STAFF REPORT and TENTATIVE DECISION

Type-2 Land Use Application — Administrative Review

Date: December 9, 2021 Item: SPR 2021-011
Prepared by Lois De Benedetti Site Development Plan Review

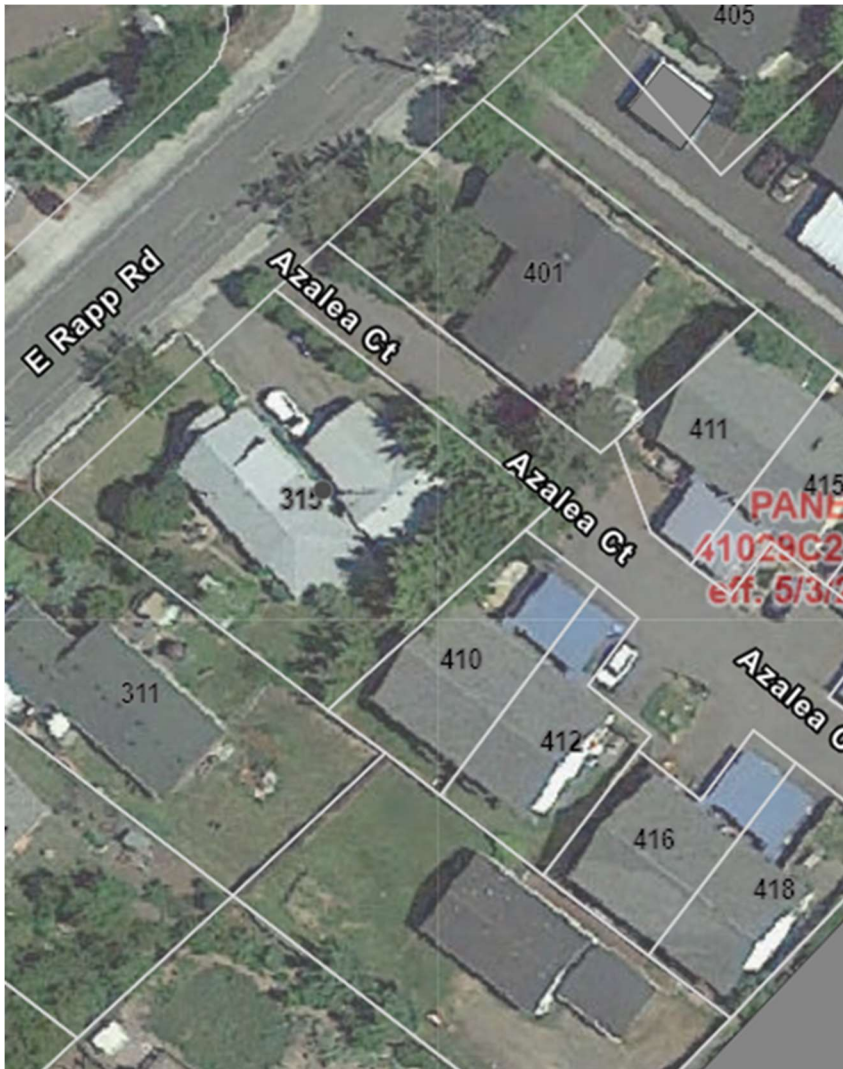
FINDING: 20% of the gross site area, or minimum 1,769 SF has been provided as public open space. Proposed Units #1 and #3 each have 95 SF private yard space and 63 SF private patio space; Units #2 and #4 do not have adequate private space. **The provisions of this section can be met subject to conditions of approval.**

FINDING: Revised site plan shows parking angled at 30 degrees (In this configuration standard parking dimensions required are 9'x17'), located outside of the front yard and outside of the street side yard setback. Proposed 10' wide driveway is to be constructed of a durable and dust-free hard surface, and is located off of a private driveway. **The provisions of this section have been met.**

1. Applicant must submit proposed site plans to RVSS that show all areas of proposed impervious surface. If the proposed impervious surface is above 2,500 sf when compared to the pre-fire impervious surface footprint, the development must demonstrate compliance with the Rogue Valley Stormwater Quality Design Manual prior to the start of construction:
2. Applicant must submit proposed site plans to RVSS that show all areas of proposed impervious surface. If the proposed impervious surface is above 2,500 sf when compared to the pre-fire impervious surface footprint, the development must demonstrate compliance with the Rogue Valley Stormwater Quality Design Manual prior to the start of construction.
3. Applicant must submit a site plan that shows minimum 96 SF private open space for unit #2 and unit #4.
